## ADDENDUM NO. 02

### TO: PLANS AND SPECIFICATIONS FOR STATE OF MISSOURI

Update HVAC & Chiller, Troop D Crime Lab  
Troop D Crime Lab  
Springfield, Missouri  
PROJECT NO.: R2517-01

**M-002**

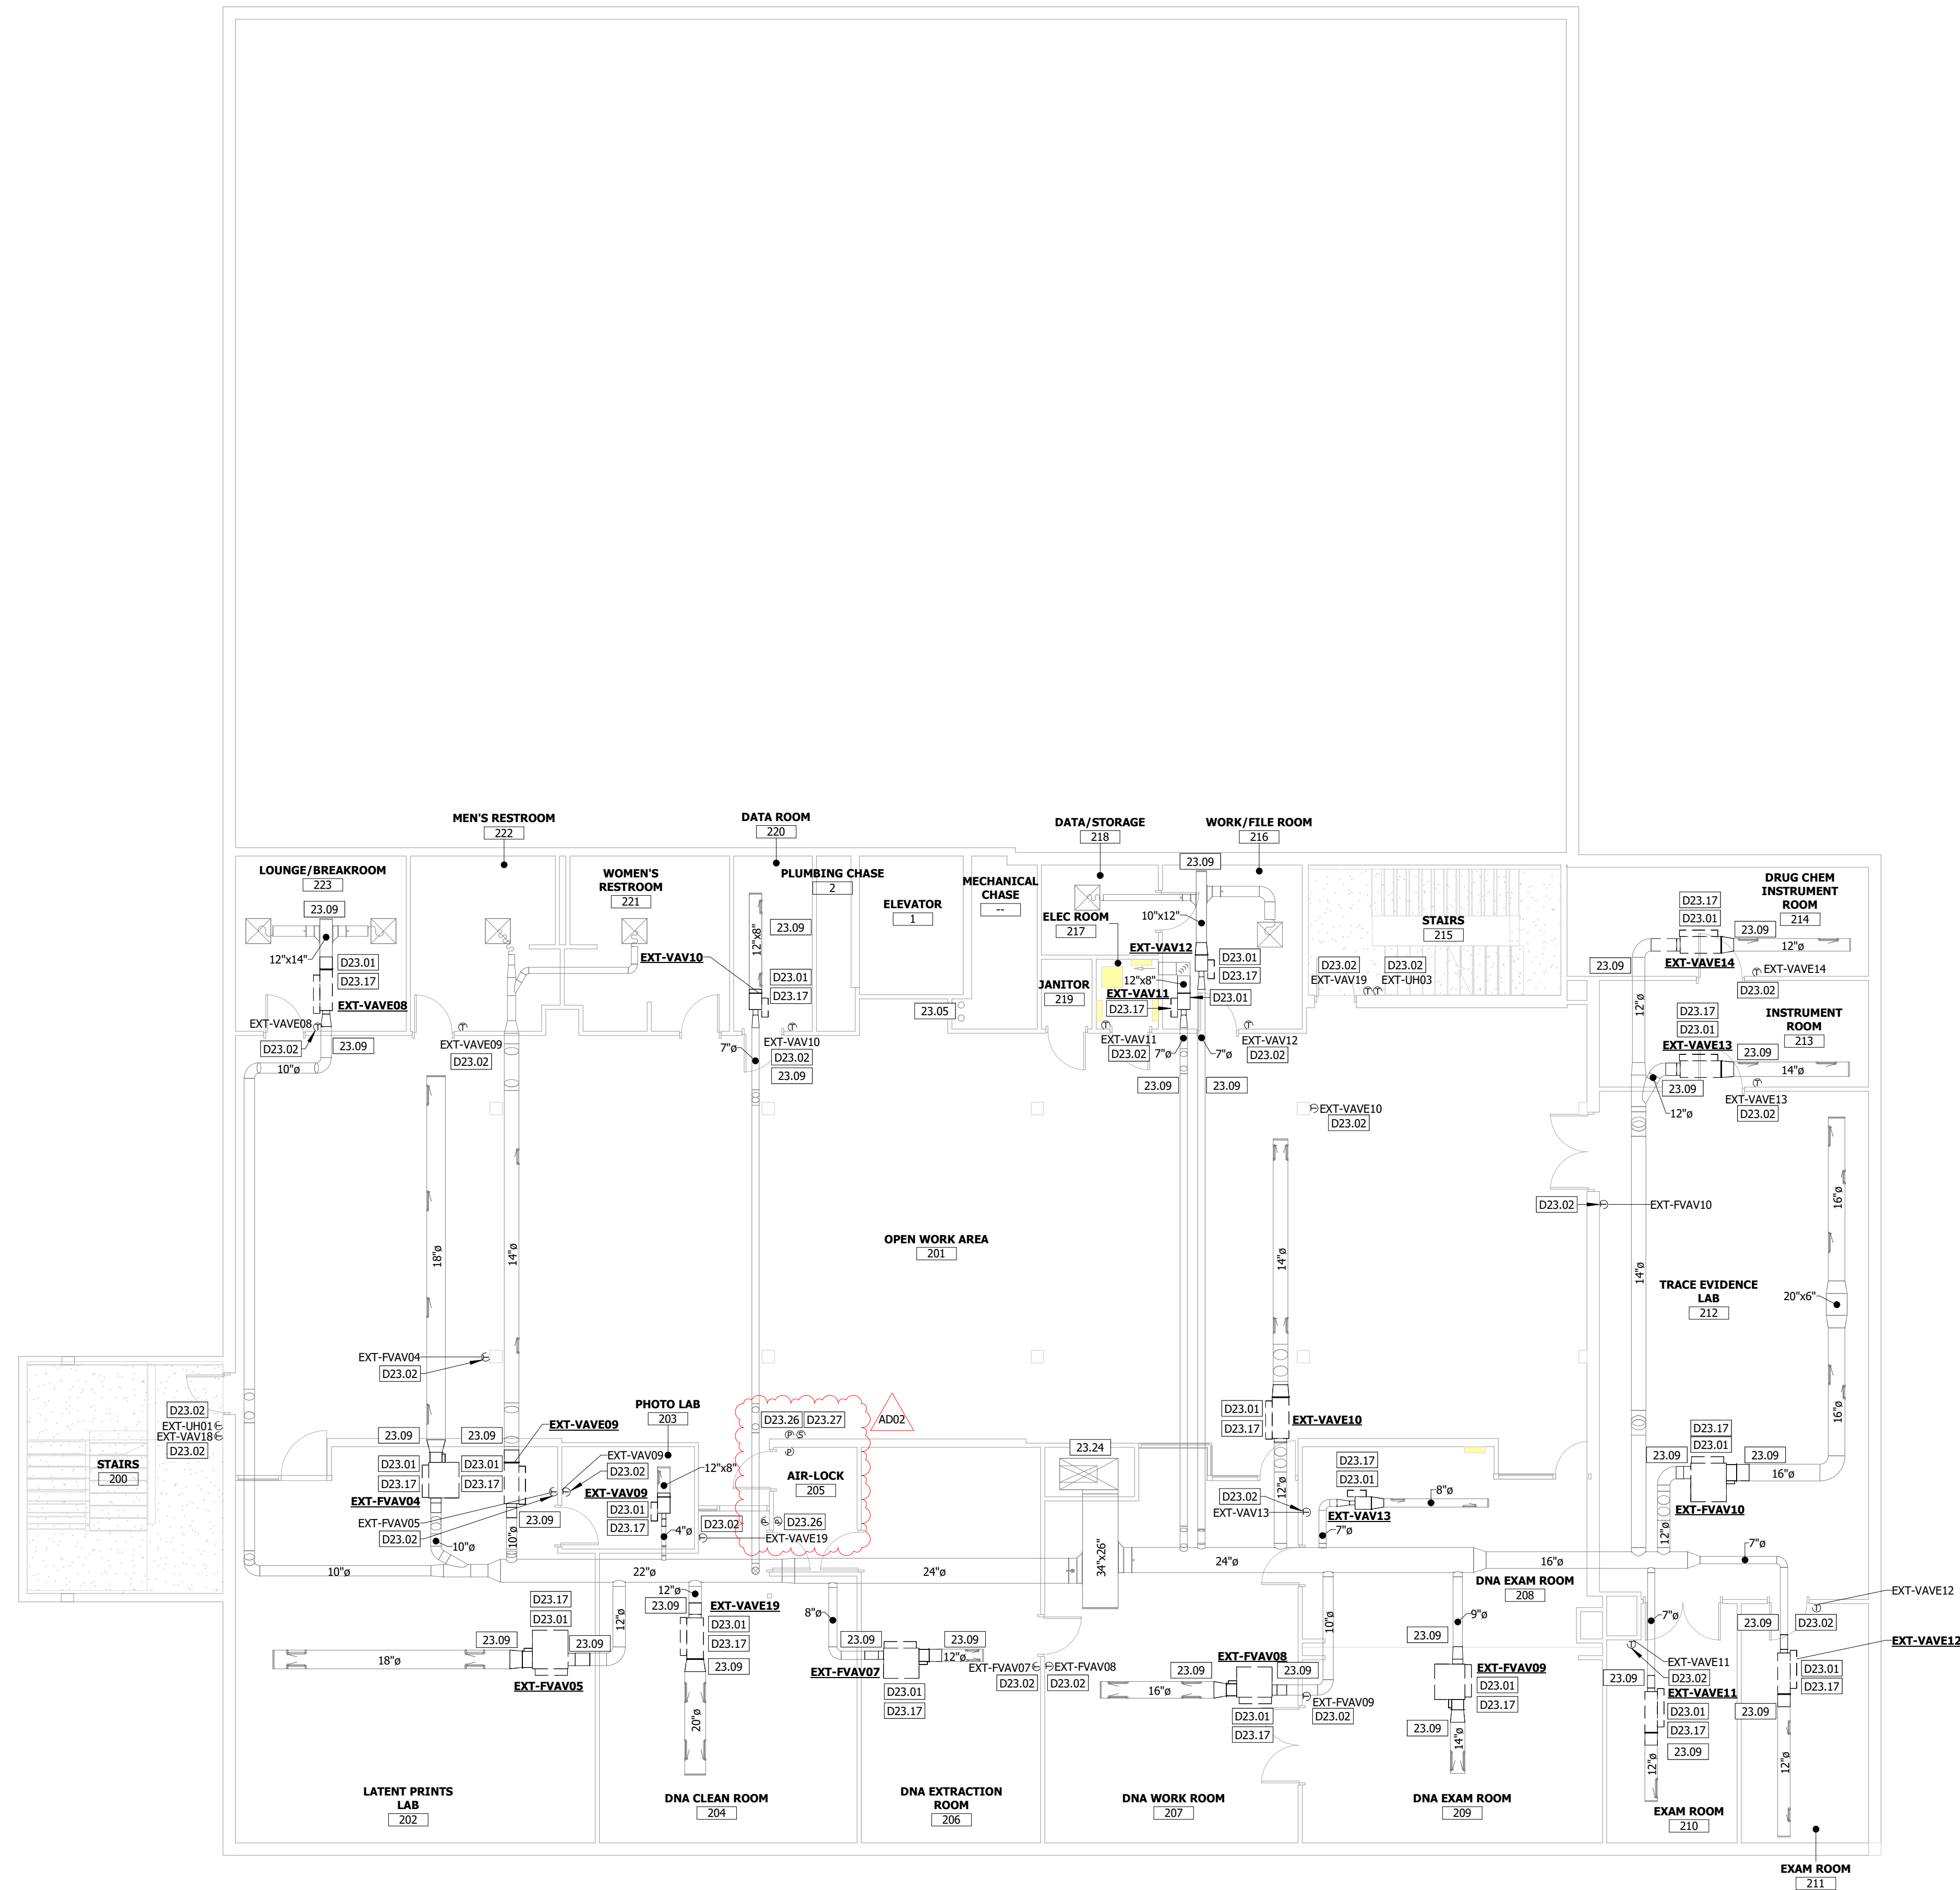
a. Remove pressure monitoring system and associated differential pressure sensors.

M-102  
9 of 27 SHEETS  
10/06/2025

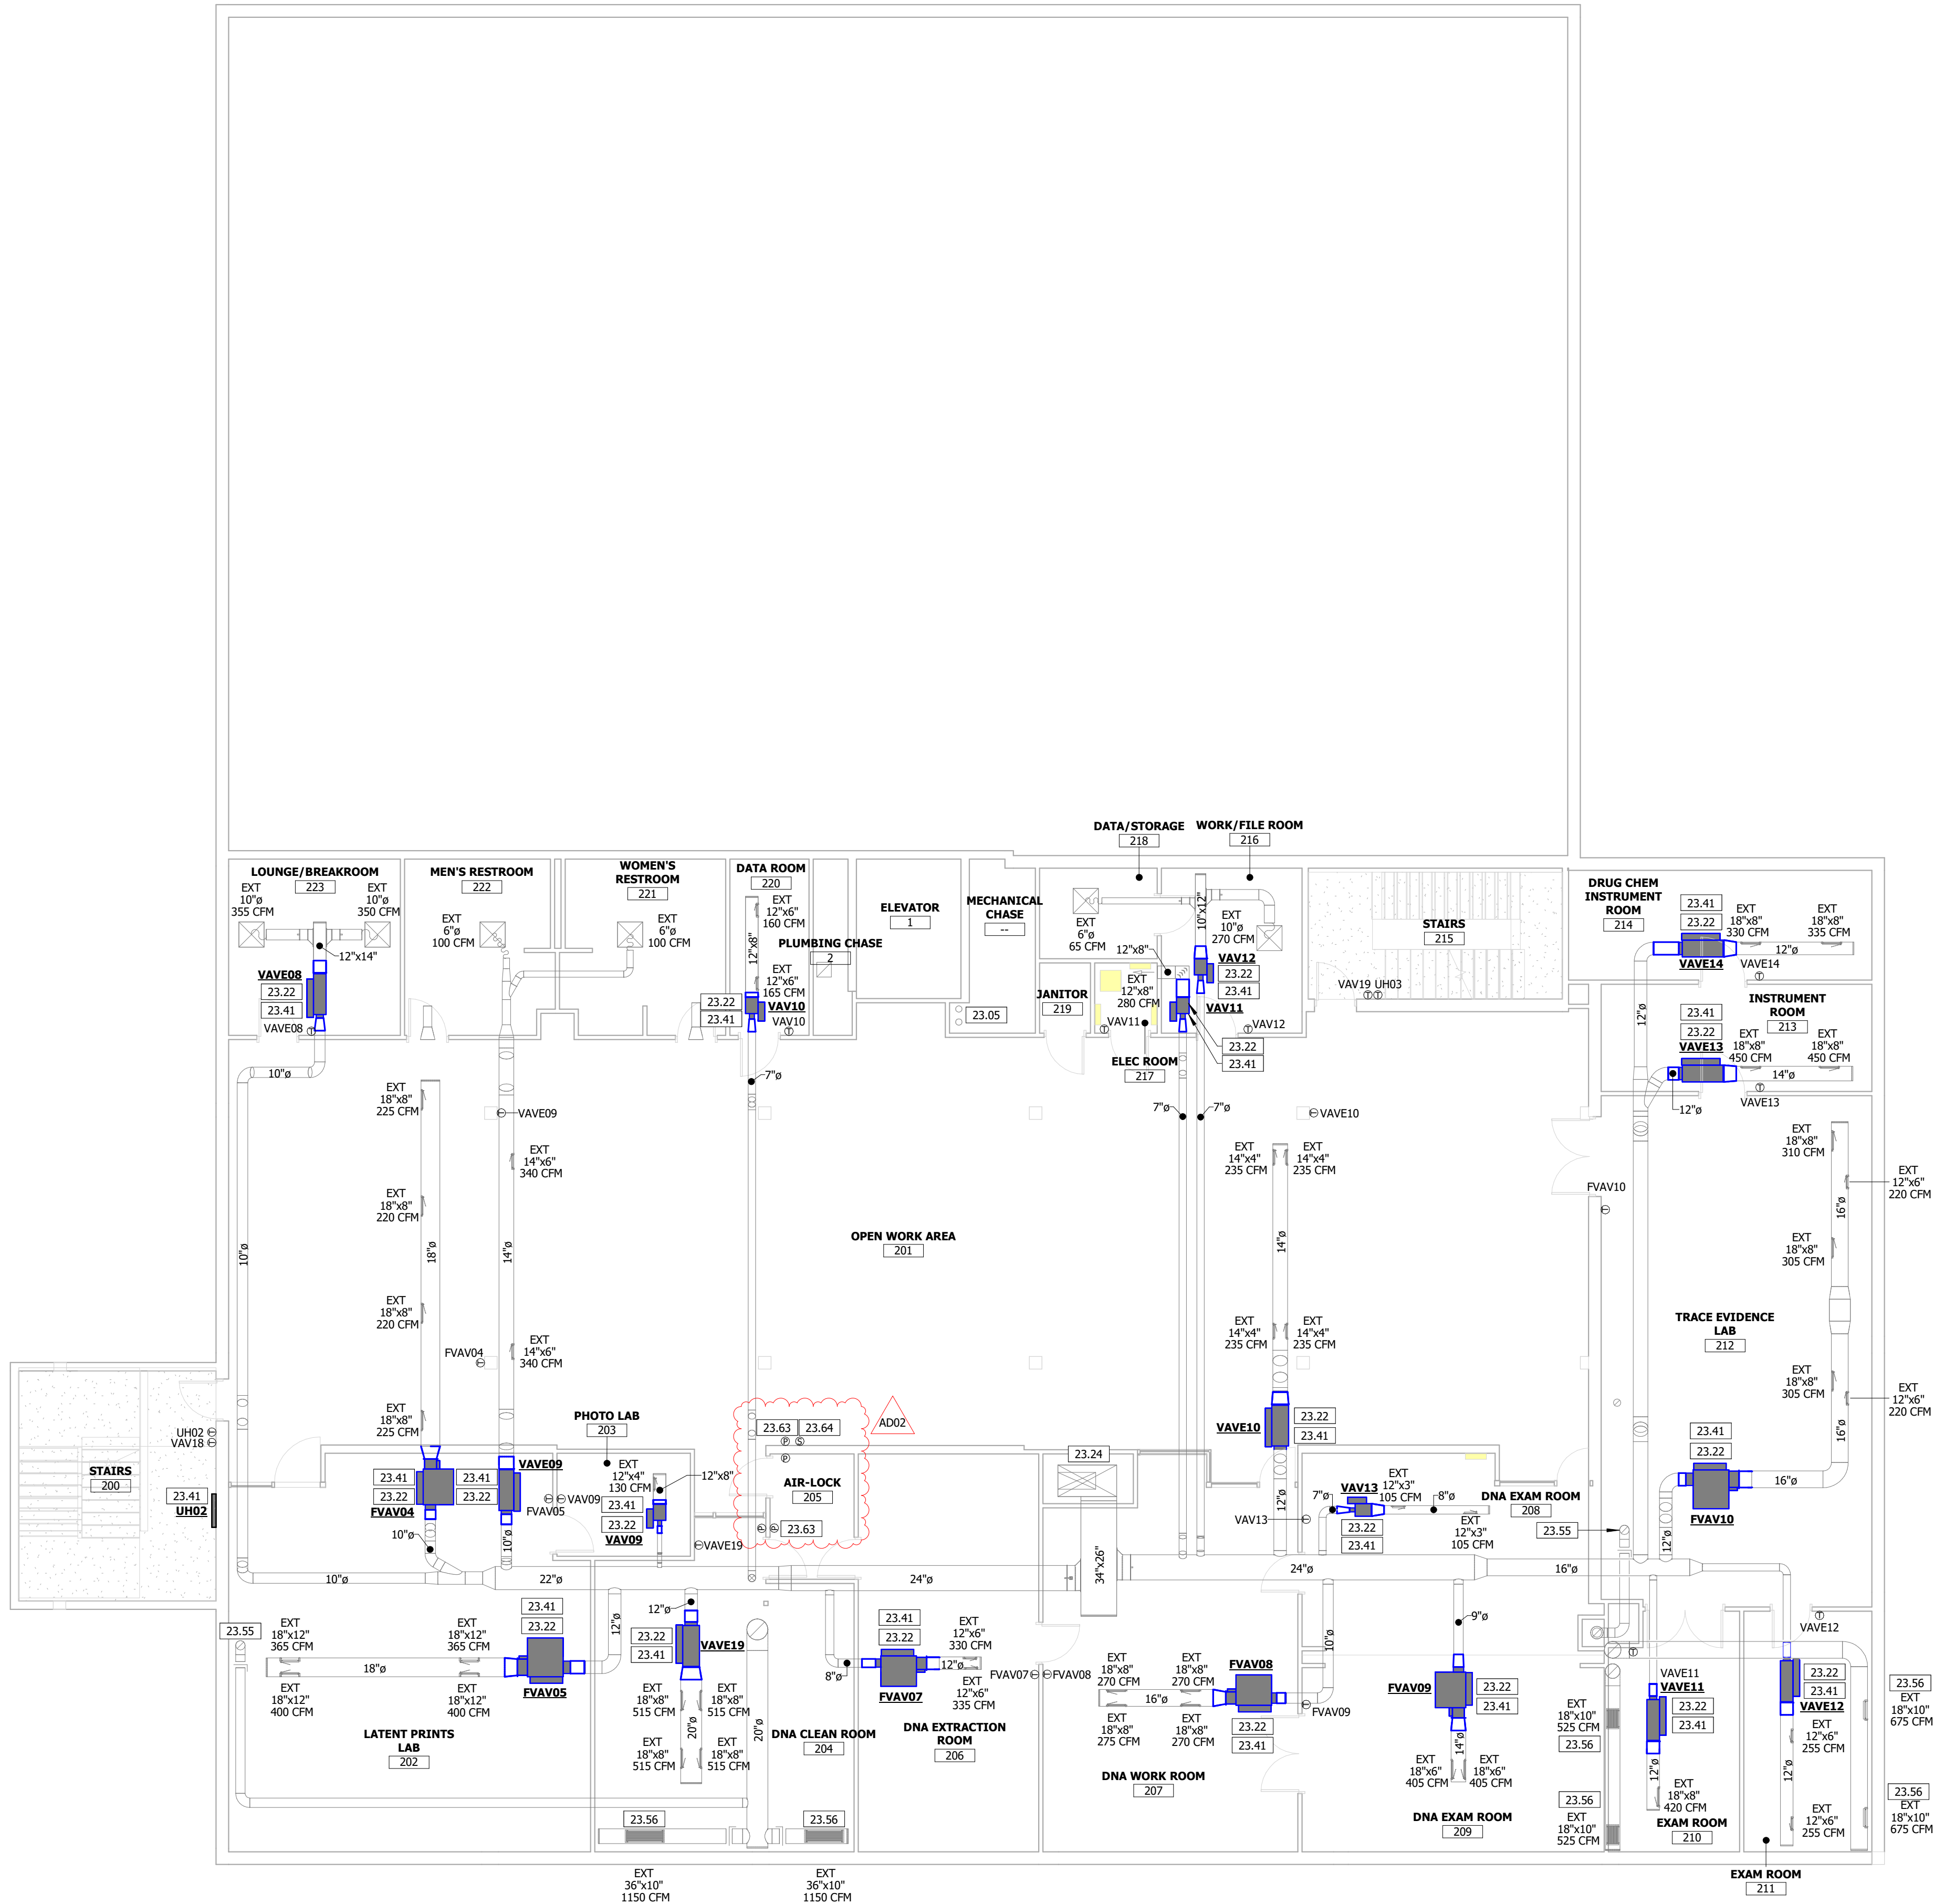
a. Provide new pressure monitoring system and associated differential pressure sensors.

2 ELEVATION DETAIL  
1/8" = 1'-0"

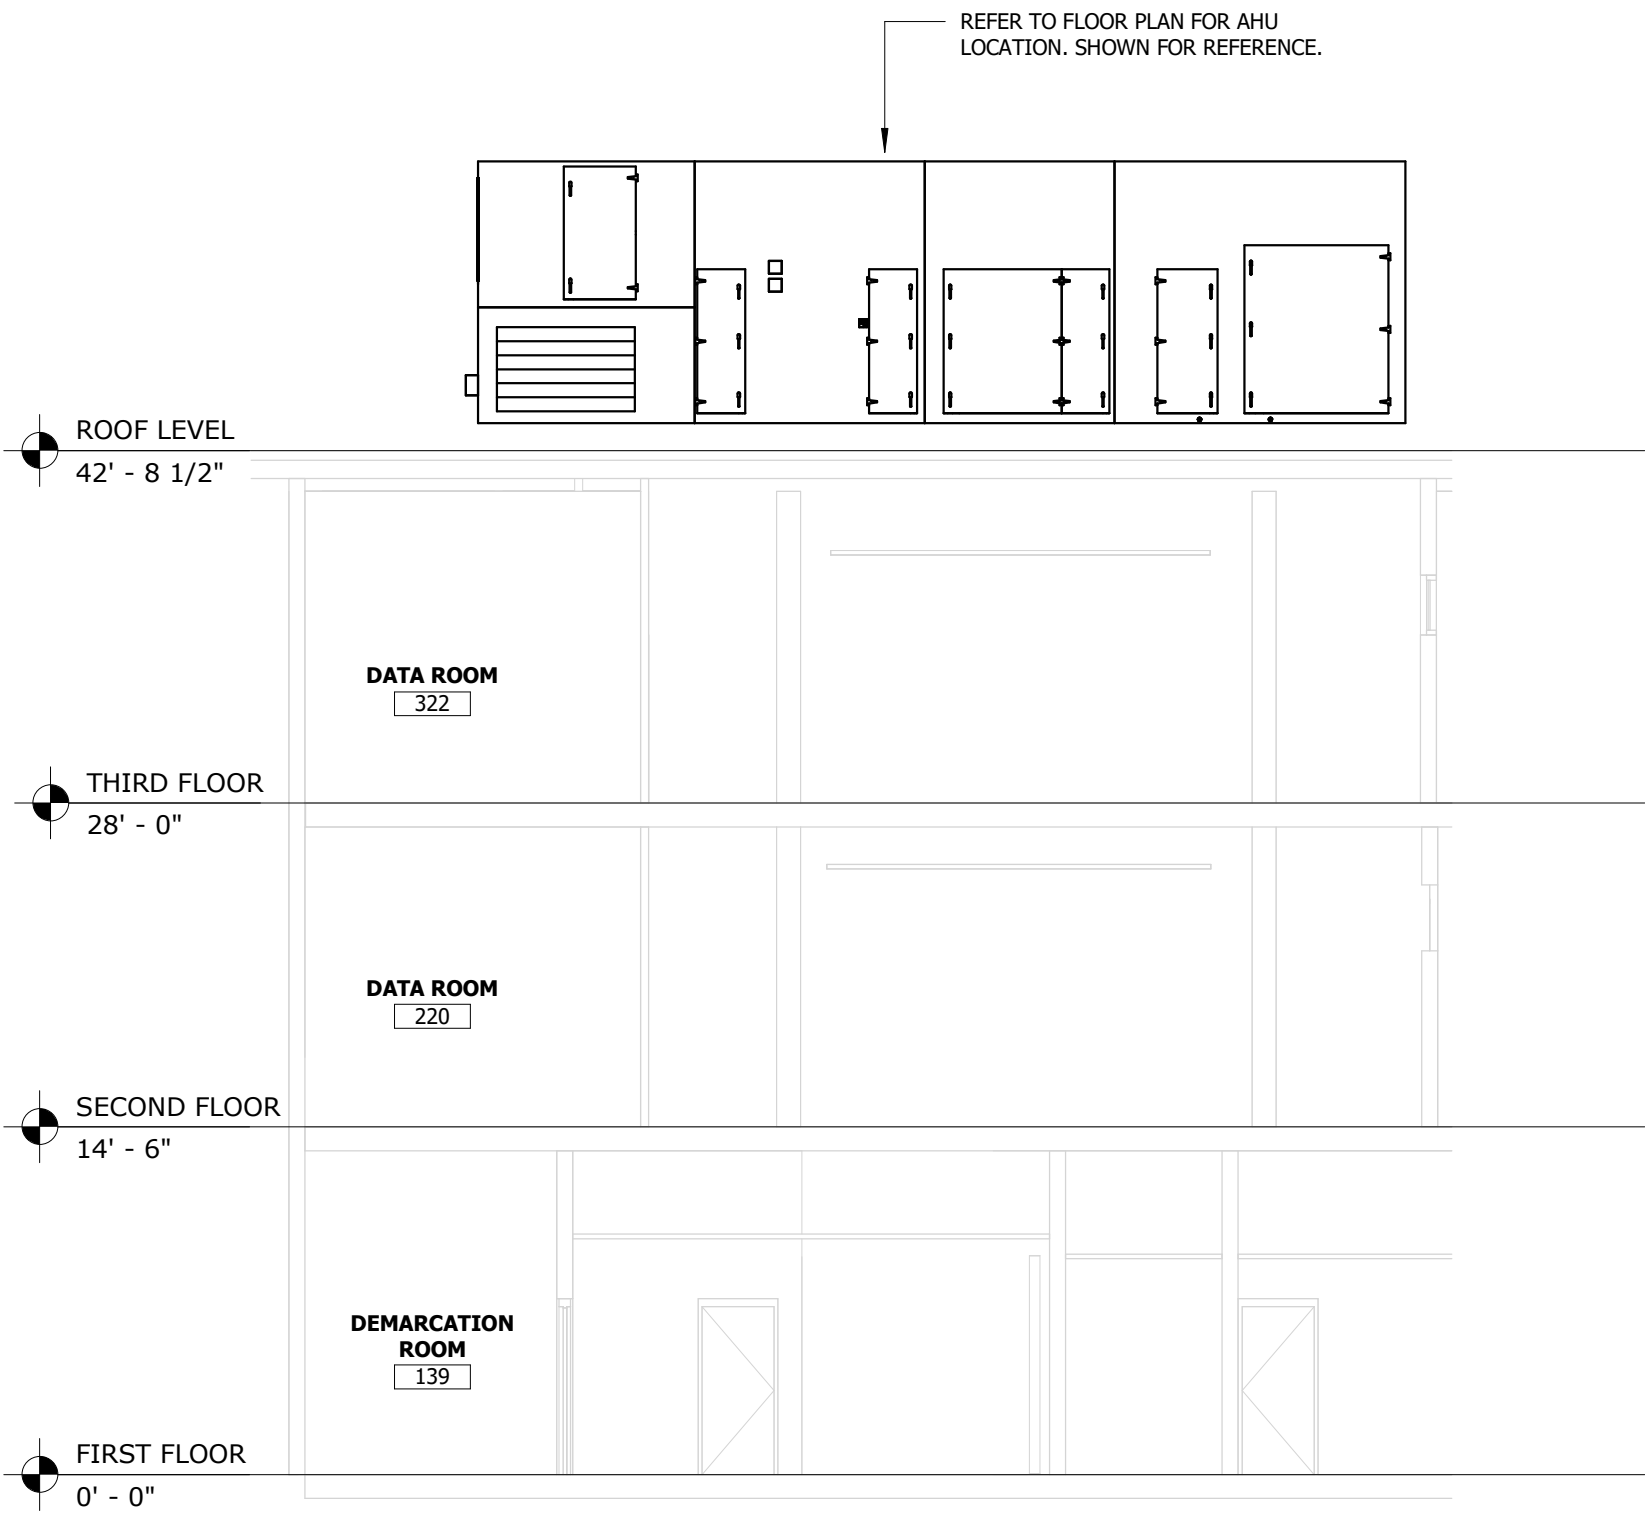
a. Added detail 2/E201 – Elevation Detail per attached sheet E-201.
